**STATE OF DELAWARE
EXECUTIVE DEPARTMENT
OFFICE OF STATE PLANNING COORDINATION**

May 23, 2011

RE: PLUS review – 2011-04-04; Bayside Mini-storage

Figure1: SWMP mapping in the immediate vicinity of the proposed project

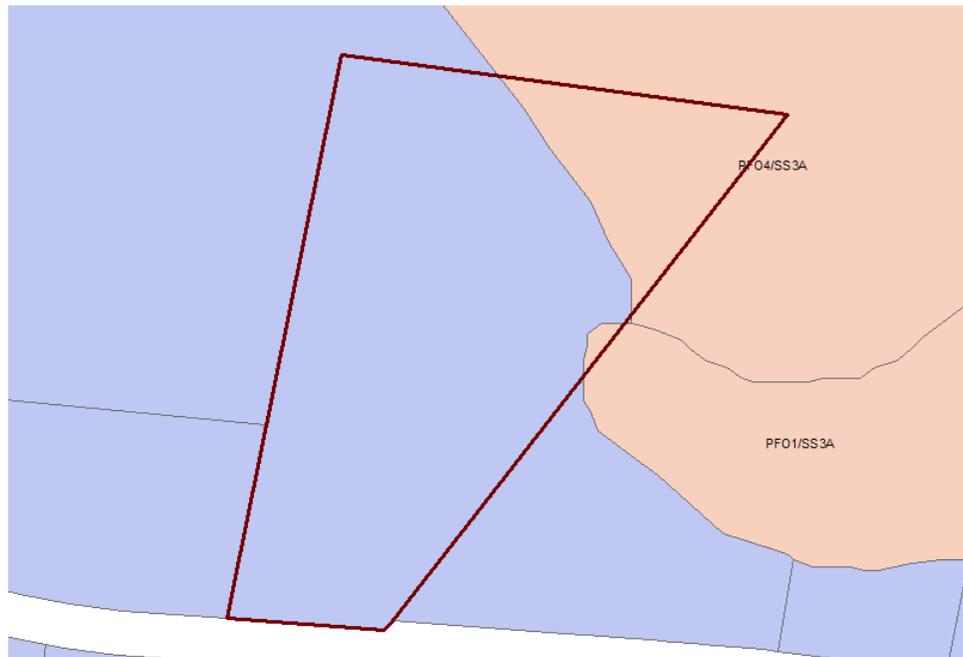
- According to the Statewide Wetland Mapping Project (SWMP) maps, palustrine wetlands (PF04/SS3A & PF01/SS3A) were mapped in the area proposed for development (See Figure 1).

- Maintain 100-foot buffer width(s) from all delineated wetlands (USACE and State approved wetland delineations). The USACE can be reached by phone at 736-9763.
